IFB No. 22-23 HVAC & Roofing Projects at Lincoln, East, Washington & Flinn Schools

RE: **ADDENDUM NO. 6**

PROJECT: IFB #22-23  
RPS 205 HVAC Improvements:  
2224 Washington Elementary School  
2245 Lincoln Middle School  
2246 Flinn Middle School  
2233 East High School  
IMEG #21002885.01, .02, .03, .04

**E001**

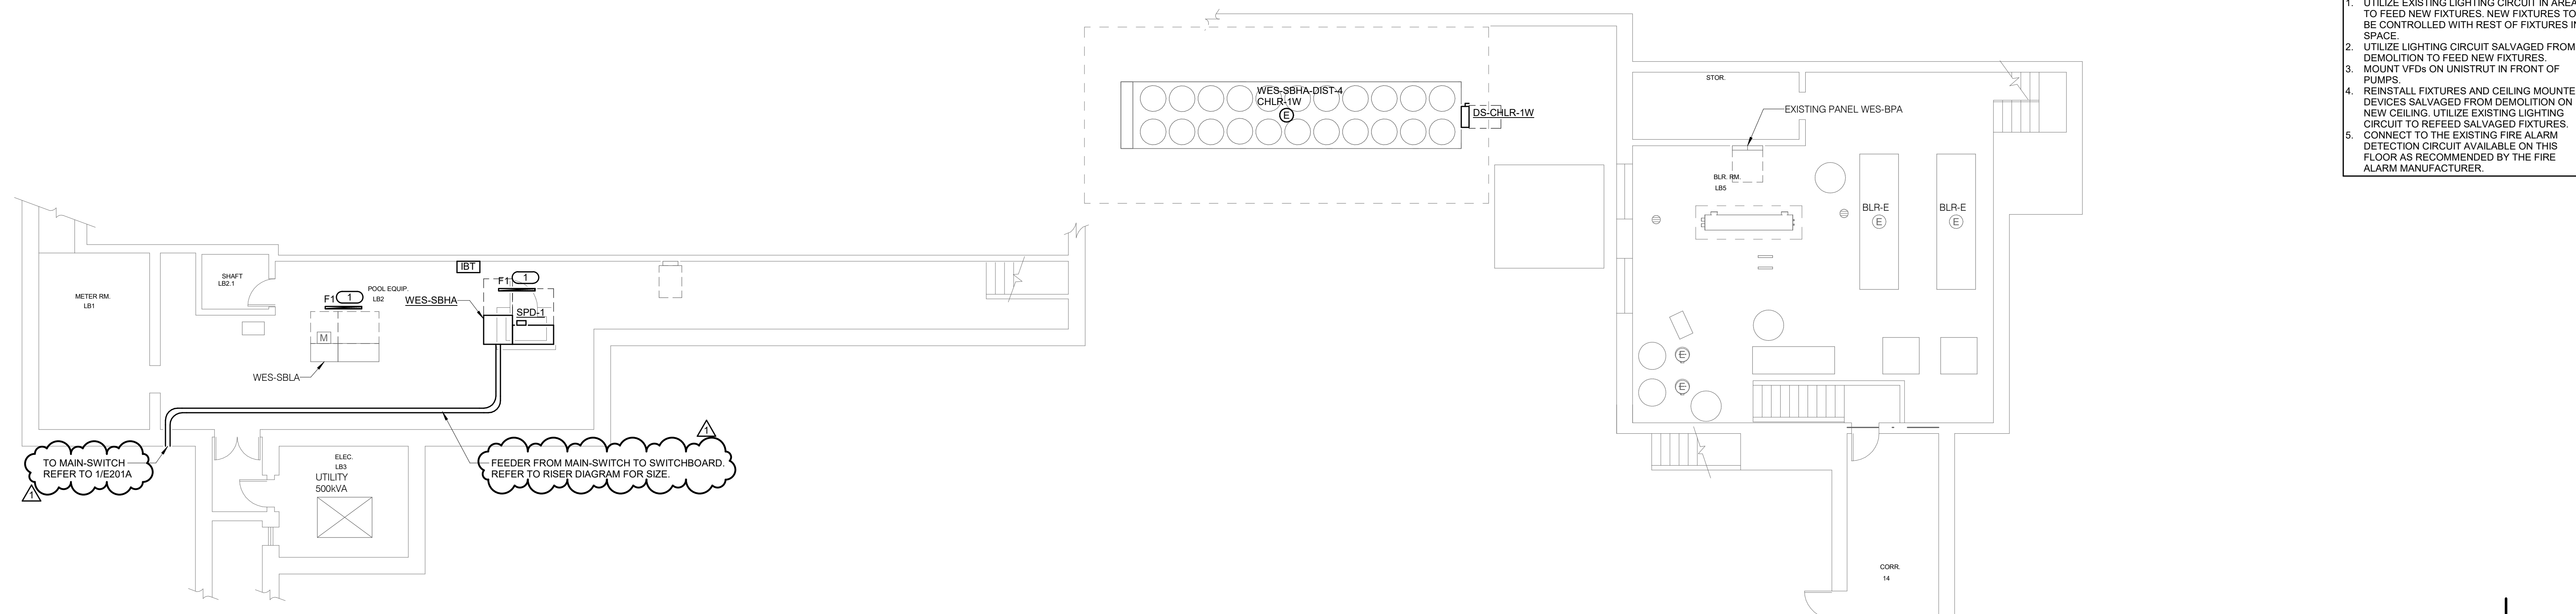
1. DRAWING E001 - SITE - ELECTRICAL
  - a. **ADD** Main-Switch between utility transformer and building.
  - b. **ADD** concrete pad for Main-Switch.
2. DRAWING E201A - BASEMENT AND GROUND FLOOR - AREA A - ELECTRICAL
  - a. **REVISE** references to the Meter Cabinet to the Main-Switch.
  - b. **REMOVE** meter cabinet and feed from utility transformer.
3. DRAWING E501 - ELECTRICAL RISER DIAGRAM - NEW
  - a. **ADD** Main-Switch between the utility transformer and WES-SBHA.
  - b. **ADD** feeder from utility transformer and Main-Switch.
  - c. **REVISE** feeder to WES-SBHA.
  - d. **REVISE** grounding location to Main-Switch.
  - e. **REVISE** main breaker in WES-SBHA to LSI.
4. DRAWING E700 - PANEL SCHEDULES
  - a. **REVISE** main breaker in WES-SBHA to LSI.
  - b. **REVISE** fed from for WES-SBHA to Main-Switch.

**E501**

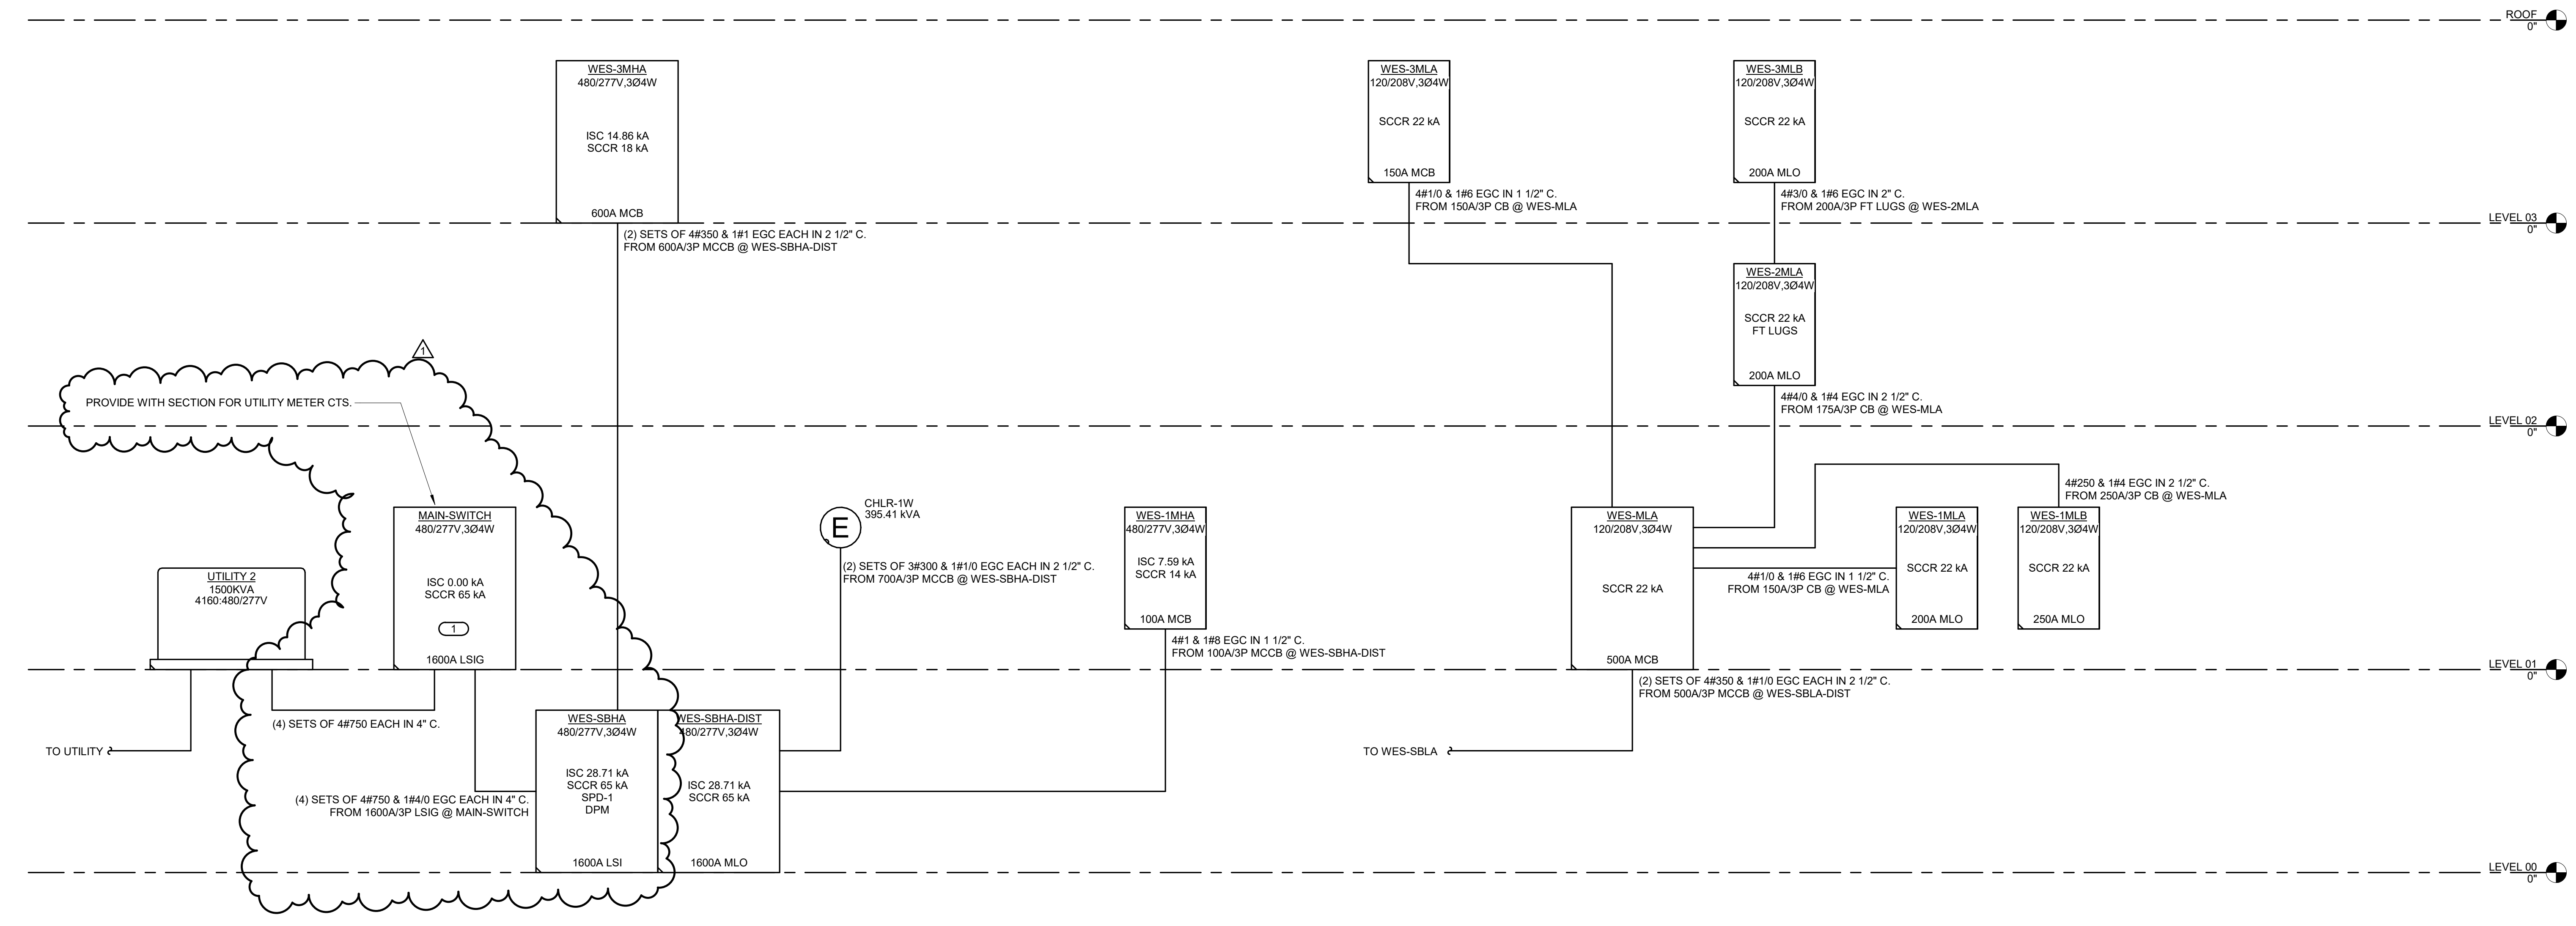
**Response:** Refer to Drawings section of addendum for revisions.
  - b. The one line diagram does not show the external metering equipment.  
**Response:** Refer to Drawings section of addendum for revisions.

- c. Also it does not show the 1600 amp main disconnect needed because the feeder length inside the building is longer than the utility company allows before the main breaker.

**Response:** Refer to Drawings section of addendum for revisions.
  - d. I believe the intent was to be a 1600 amp version of what the Lincoln school drawings shows.
